UNITED STATES PATENT AND TRADEMARK OFFICE

Office Action Summary

10/821,597

DETAILED ACTION

FIG.2A

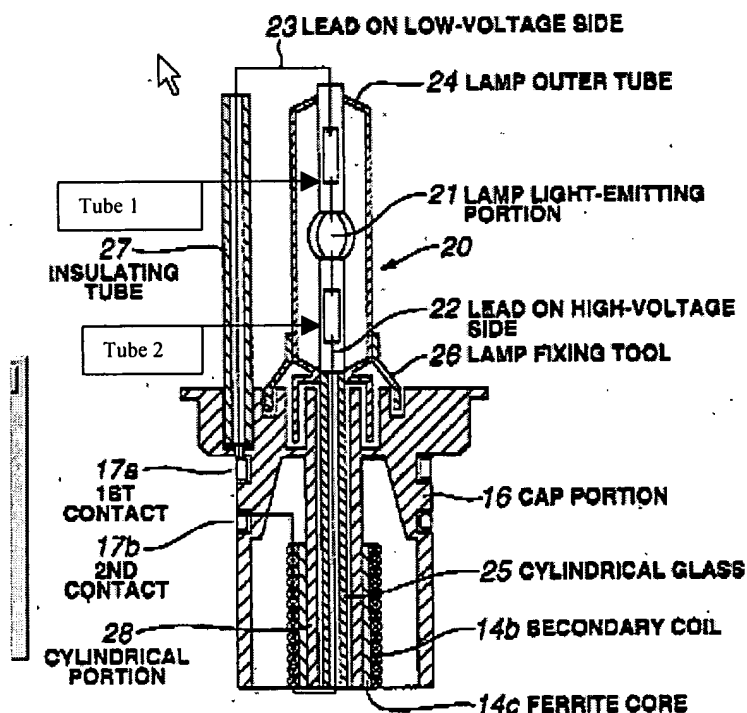
Kika teaches a headlight for a motor vehicle comprising a base 50, a light device including two light member 20 (fig. 9), round cylindrical glass cover 21, two tubes (not labeled in fig. but labels were added to fig. 2A below) coupled to the light members and partly outside the cover, two cables 22 and 23 coupled to the light members for power, and a controlling means [0169] comprising a stabilizer 12 and a control line g for operating a switch to control the lighting operation, circuits shown in figure 3A-3B, and socket portion 11.
